Applicant: **Chung** Filing Date: **12/11/01**
Docket No.: **AMD-F0958** Serial No.: **10/015,033**
Title: **A SWITCHED CAPACITOR CONTROLLER TO
CONTROL THE RISE TIMES OF ON-CHIP
GENERATED HIGH VOLTAGES**

For: A SWITCHED CAPACITOR
CONTROLLER TO CONTROL
THE RISE TIMES OF
ON-CHIP GENERATED
HIGH VOLTAGES

AMENDMENT AND RESPONSE TO OFFICE ACTION

Figure 1

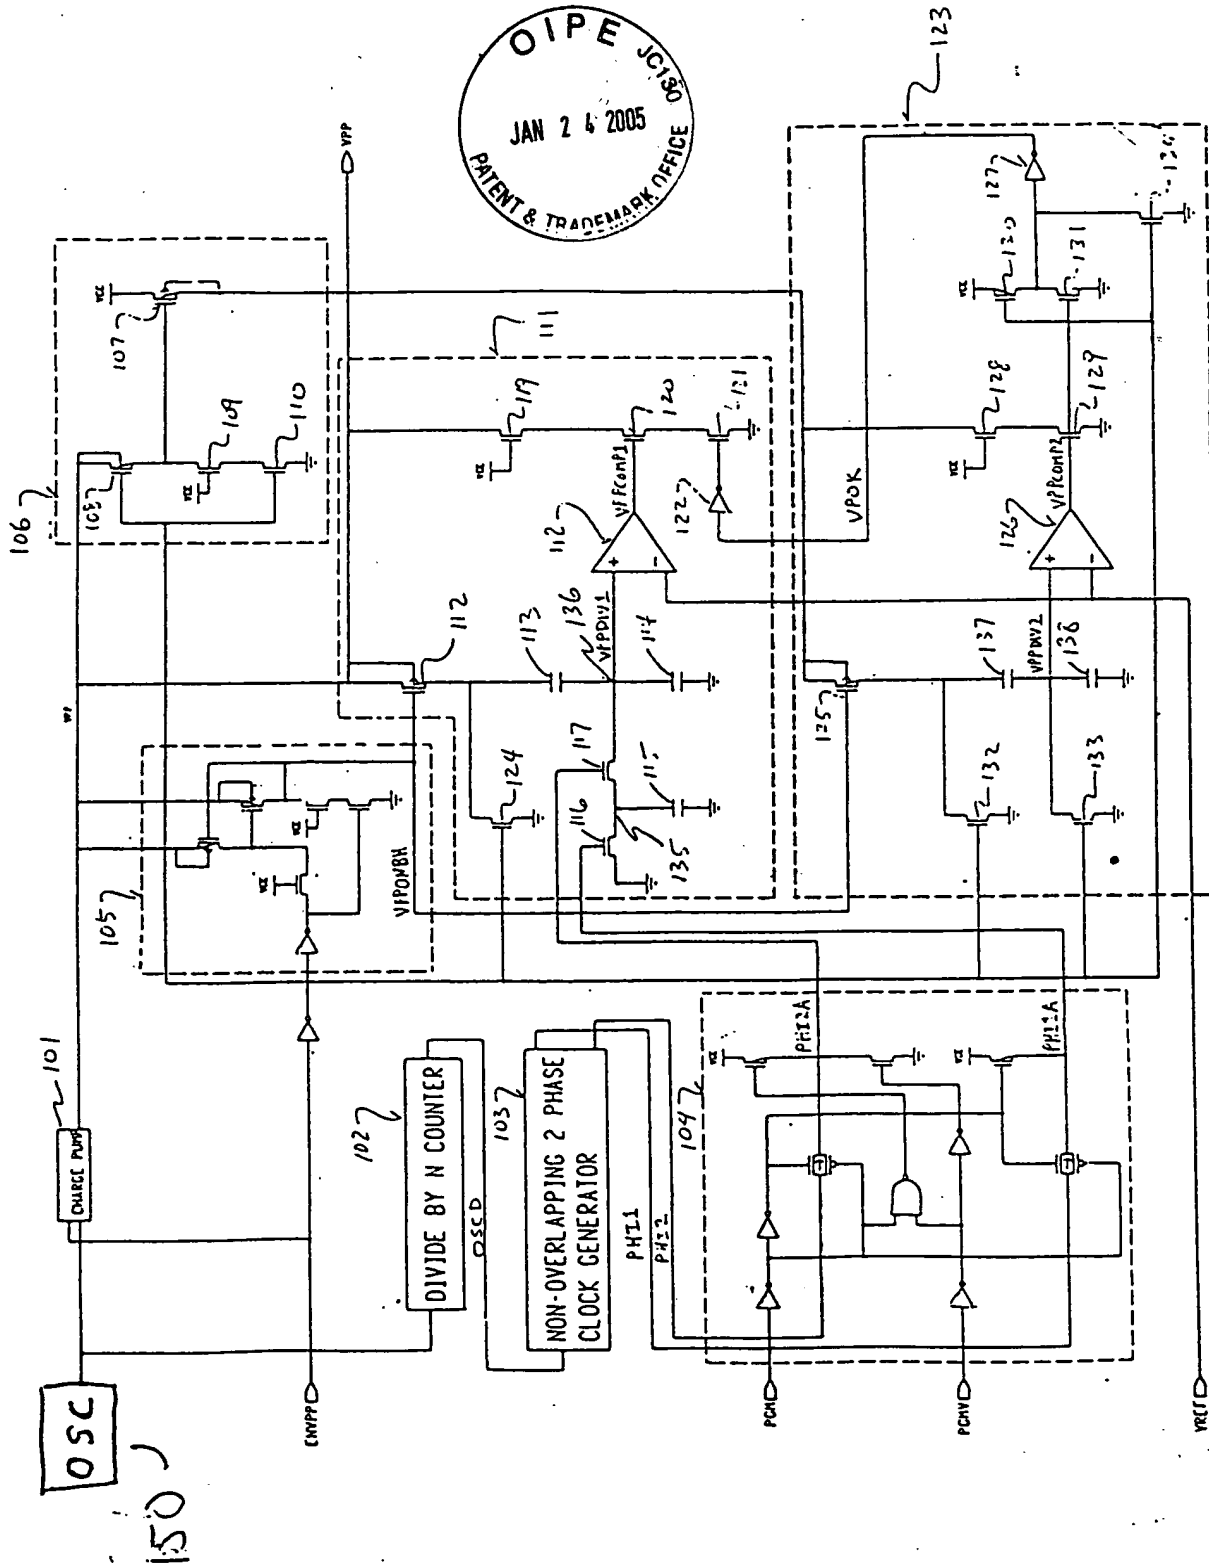
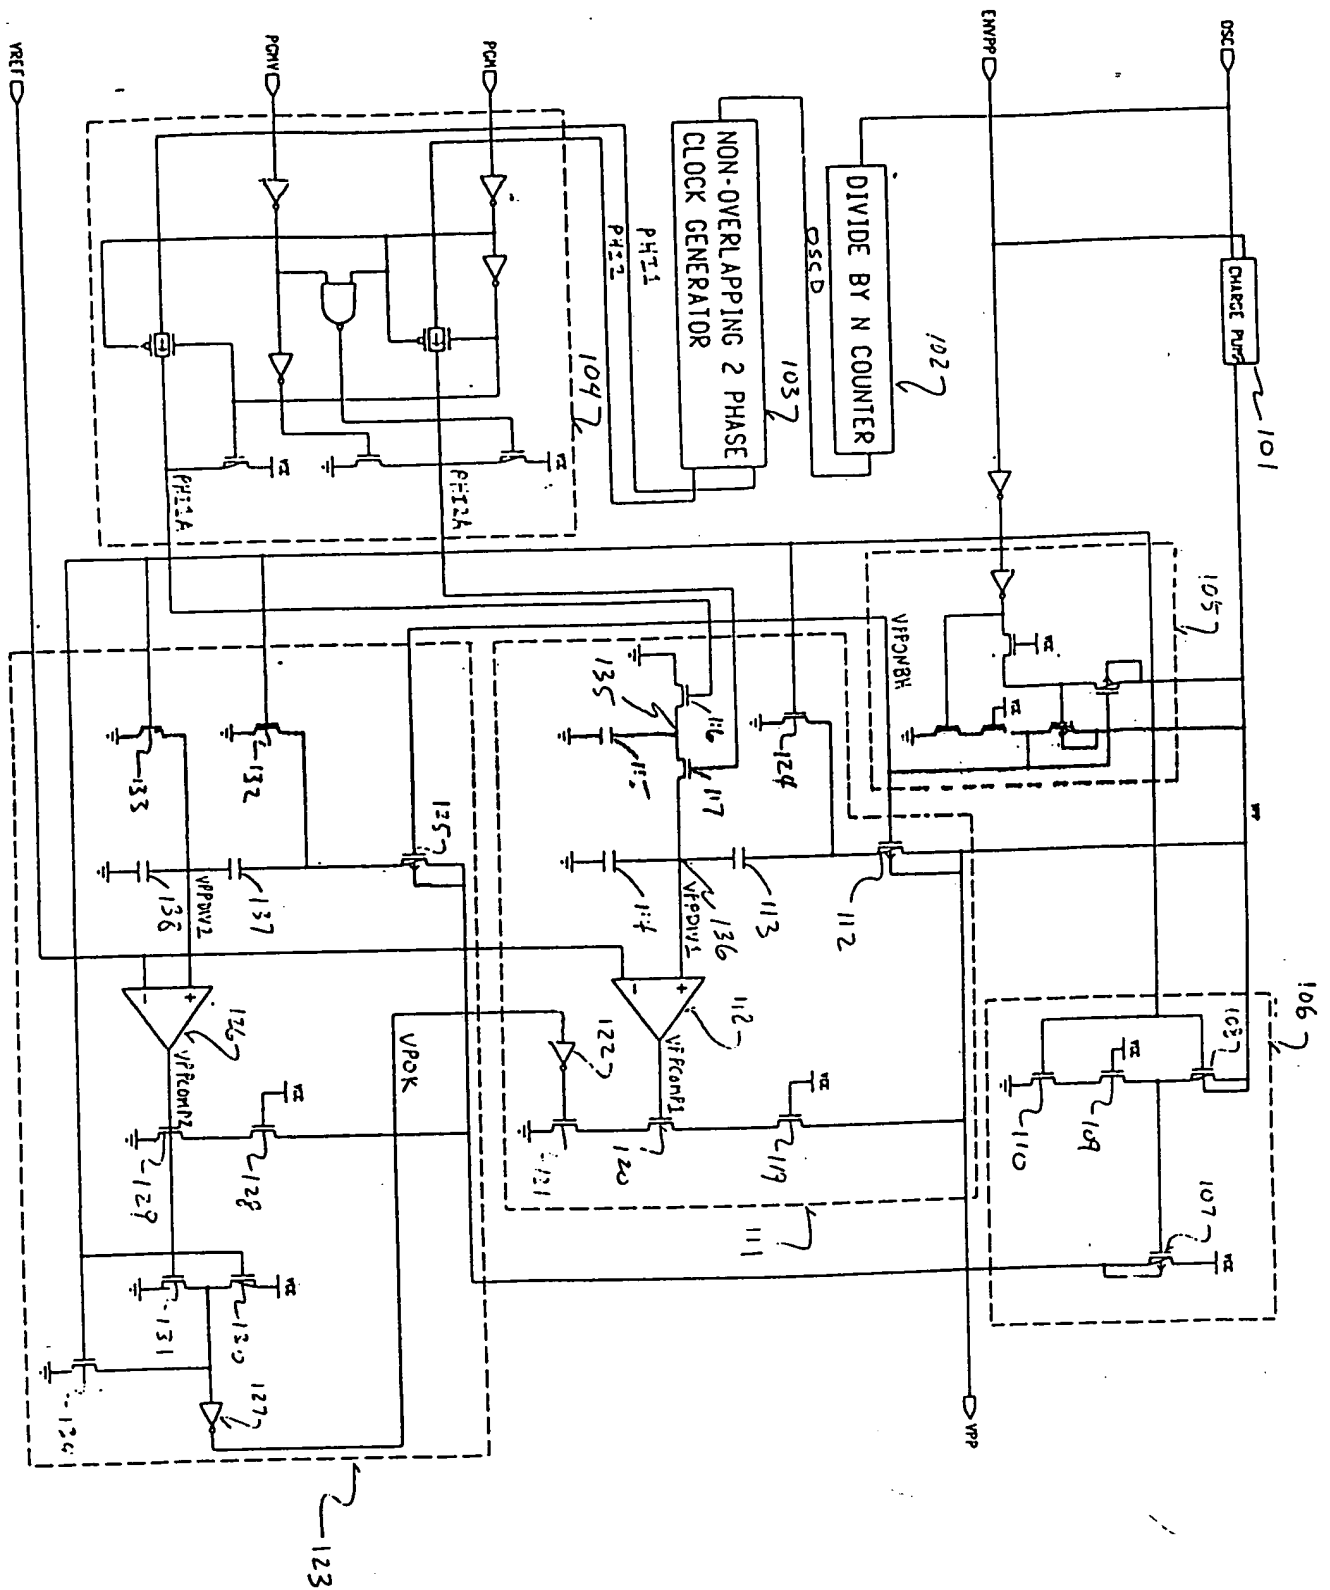
The drawings are objected to under 37 CFR 1.83(a), for an issue related to showing a ring oscillator. Applicant respectfully asserts that the ring oscillator is shown in a replacement drawing sheet for Figure 1, which was submitted with Applicant's response dated January 26, 2004, to the Office Action of September 26, 2003.

The drawings are objected to under 37 CFR 1.83(a) for not depicting the oscillators recited in Claims 9, 17, and 18. The Applicant respectfully point out that a corrected Replacement Sheet for Figure 1 was provided with the Request for Continuing Examination (RCE) filed by the Applicant on August 6, 2003, wherein this Replacement Sheet depicts the oscillator element labeled by marker label --150--. Further, the RCE filed August 6, 2003 amended the specification to effect this change to Figure 1. A duplicate of this Replacement Sheet, along with a copy of the original sheet provided for Figure 1, is attached hereto, along with a copy of the RCE of August 6, 2003. The Applicant respectfully requests the Examiner's review and approval.

The drawing are objected to under 37 CFR 1.83(a) for failing to show every feature of the invention specified in the claims. With respect to a "ring oscillator" and "oscillator," Figure 1 has been amended to include a box labeled "150" around the signal terminal "OSC" to represent an oscillator that is the source of the signal "OSC." In addition, the specification has been amended to attribute the label "150" to the ring oscillator described as the source of the signal "OSC" in the specification at page 5, lines 19-20.

A duplicate copy of Applicant's January 26, 2004 response to that Office Action, including a duplicate copy of the replacement drawing sheet for Figure 1, is respectfully submitted herewith as Applicant's Exhibit 'A,' each page of which is stamped in blue ink with the word 'Duplicate.' Further, Applicant respectfully asserts that the subject ring oscillator is also shown in a replacement drawing sheet for Figure

An amended Figure 1 is attached. The amendment to Figure 1 is described in the Remarks. No new matter has been added.

Claim 1 has been amended to replace the misdescriptive term "a switched capacitor circuit" with a reference to a "ramp generator." The ramp generator is shown as block 11 in Figure 1, and comprises a first capacitor and a second capacitor.
